FEDERAL PROJECT NOS. CMAQ-STP-BUILD-5617(602)
BPS PROJECT NO. 2020-40-012

ADDENDUM NO. 2

20TH STREET MOBILITY IMPROVEMENTS

DATE: **9/3/24**

Revision No. _____ Date _____

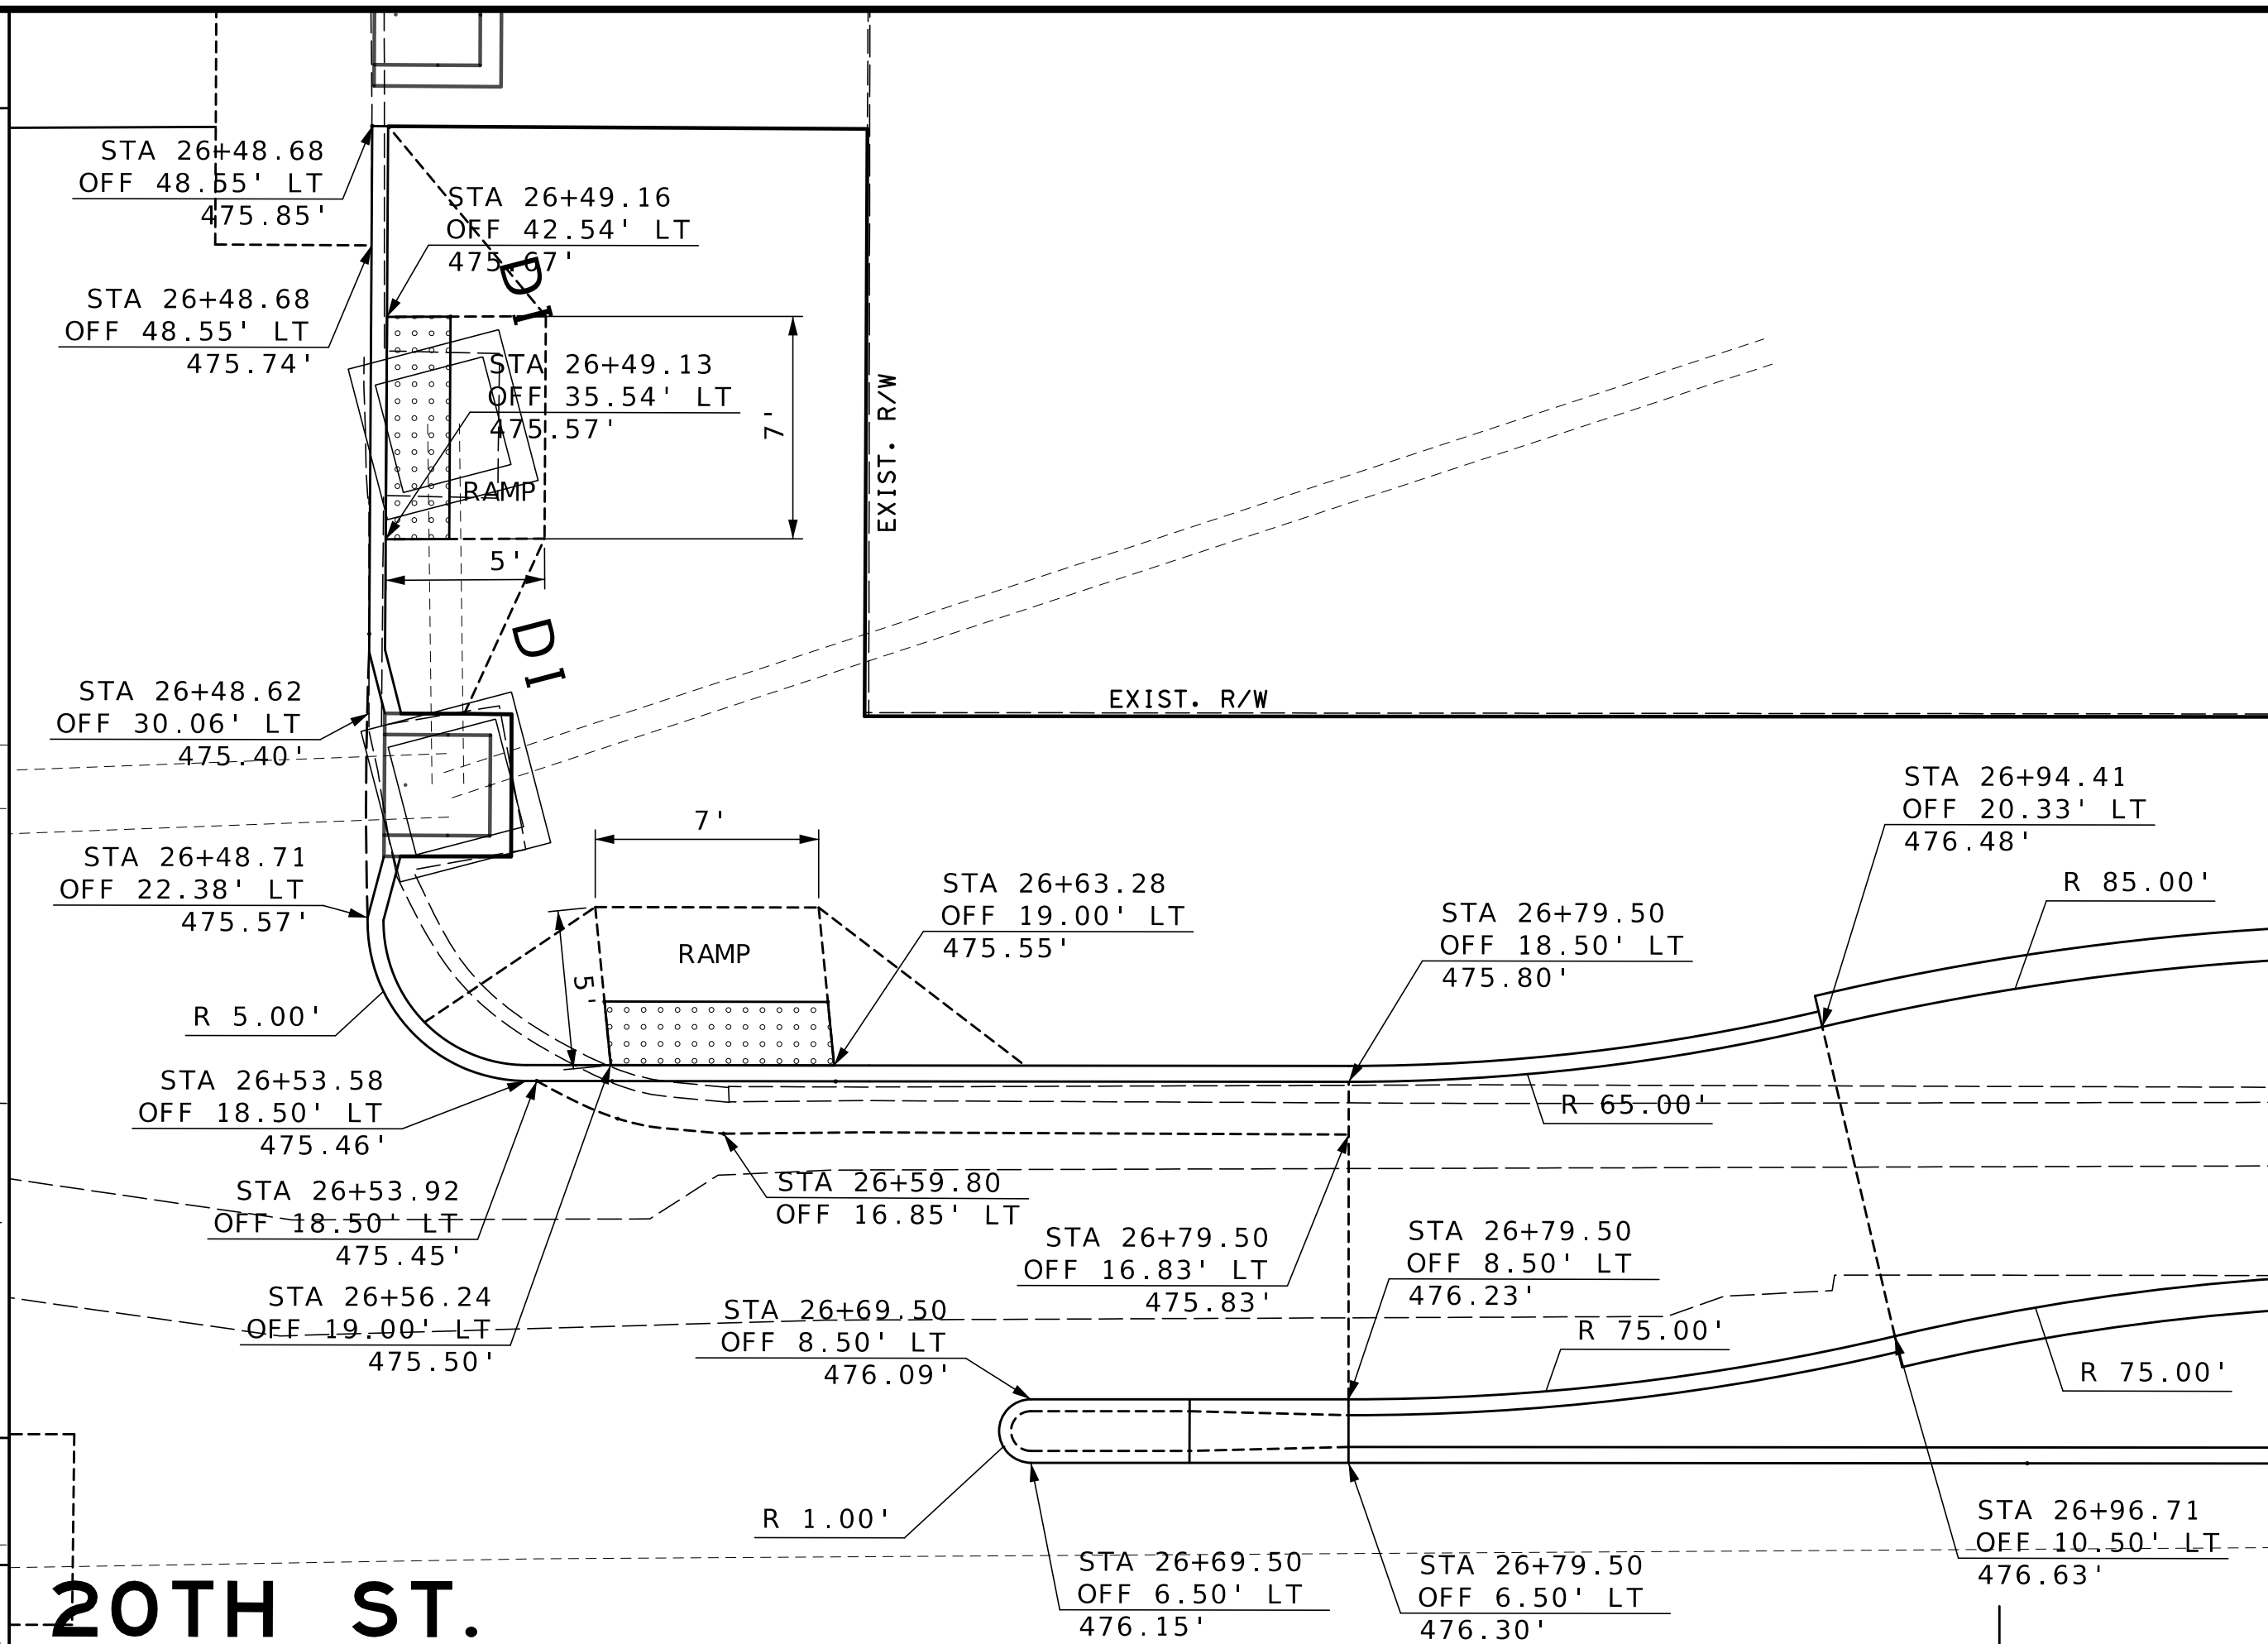
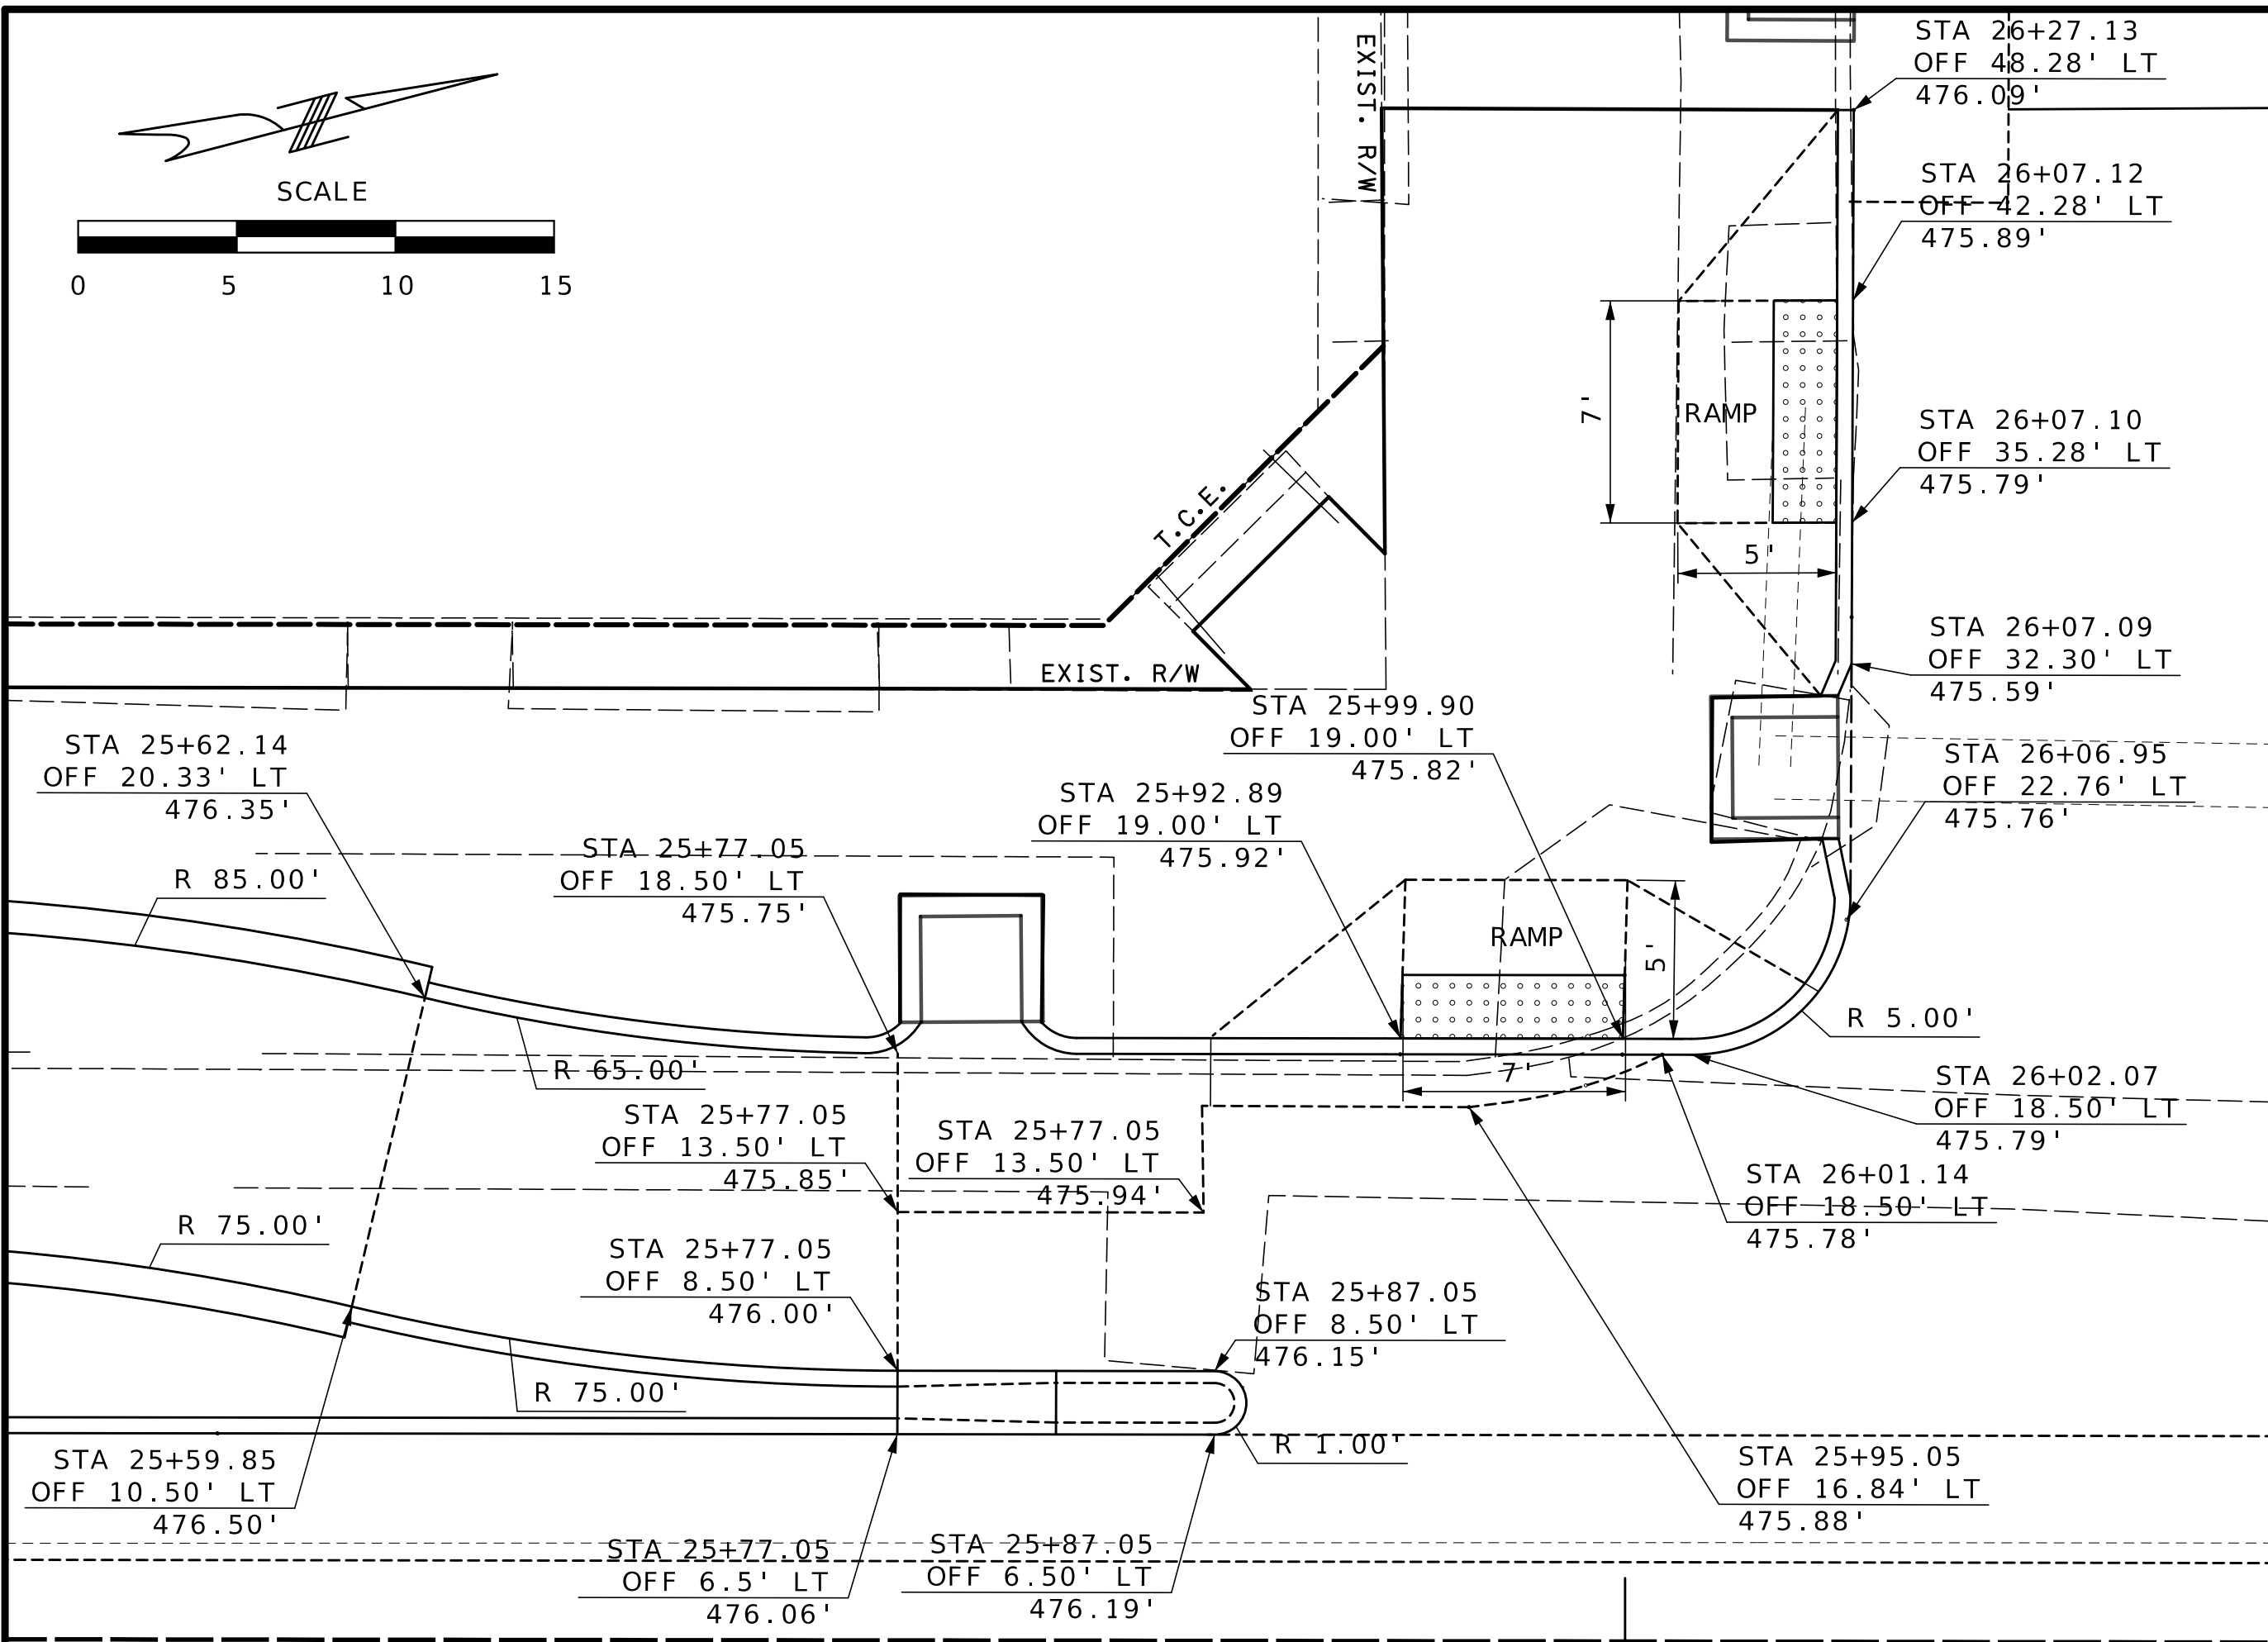
- **Sheet C2.2**: Image on the plan sheet has been revised to better represent the light poles.
- **Sheet LI-47**: Corrected catalog number of the light fixture.
- **Sheet C9.3**: Stationing and elevations at the northeast corner of the 20th/Locust intersection have been revised.

Q: JSP UUUU list different light poles and luminaires from what is shown on the plans.

A: The plans and JSP UUUU have been revised to show the correct catalog numbers of poles and light fixtures. There are no revisions to the bid quantities.
